MEMORANDUM

To: Greater New Haven Water Pollution Control Authority
From: James M. Pretti, Jr., P.E.
Date: 3/28/2016
Re: Arch Street Pump Station Rehab. Project – Addendum #2
CE File No: 2014.017
cc: file

**ARCH STREET PUMP STATION REHABILITATION
#151 ARCH STREET
HAMDEN, CONNECTICUT**

**CONCRETE SIDEWALK
DETAIL**

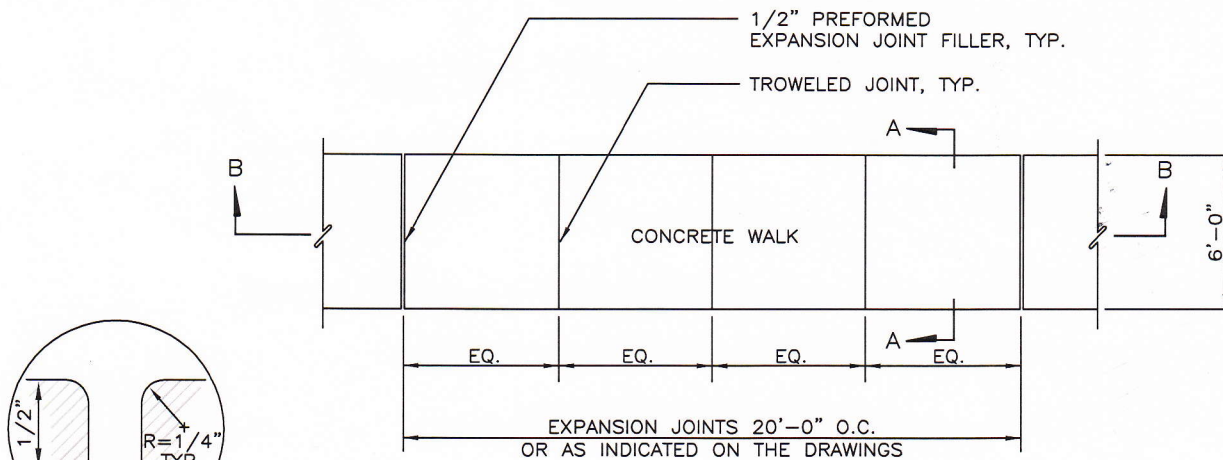
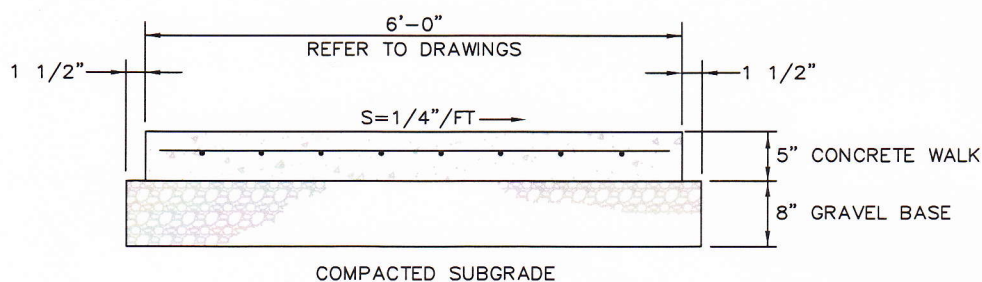
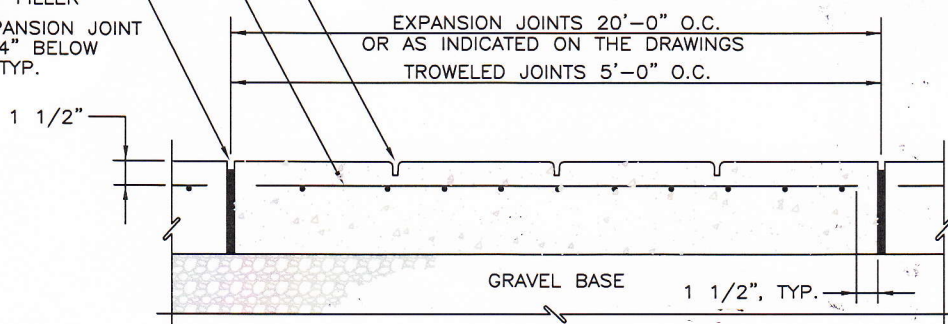
Drawing #A101 – All concrete sidewalks are to be replaced with the addition of some other small areas. See attached sketch.
